RE: New Inglewood Basketball and Entertainment Center Project AB 987 Application  
(Clearing House Tracking No. 2018021056)

On behalf of MSG Forum, LLC, we write in response to the Clippers' supplemental arguments regarding their AB 987 application for certification.<sup>1</sup>

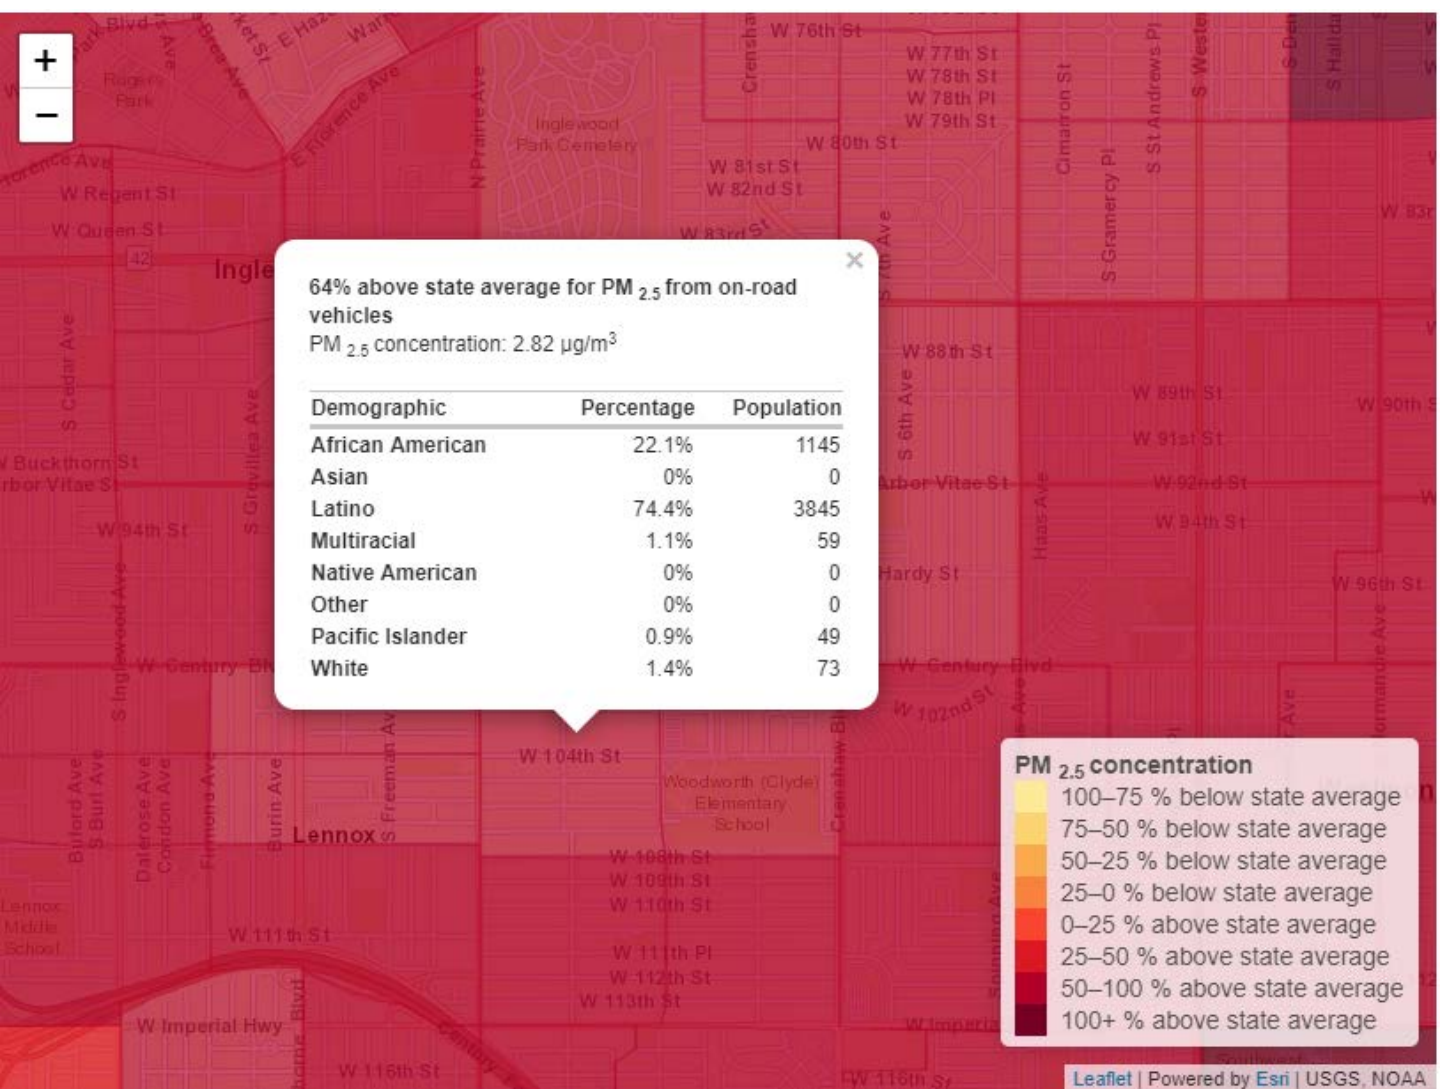
**2) *The Revised Application AB 987 (Exhibits to Supplemental AB 987) includes "Total Backfilled Emissions" for Clippers event days and the operation of organization office to the Proposed IBEC Project emissions.***

AECOM addressed the comments about backfilled emissions associated with the reused Clippers events at Staples Center and Clippers Office space, and incorporated them in the project indirect emissions (Attachment 3, Table 7a and Appendix A). While AECOM states that the results from the CSL letter (Attachment 3, Exhibit 1) were used to estimate backfilled emissions from vacated Clippers events at Staples, AECOM did not provide sufficient documentation to allow a peer review and verify that these assumptions were properly implemented in the emission inventory.
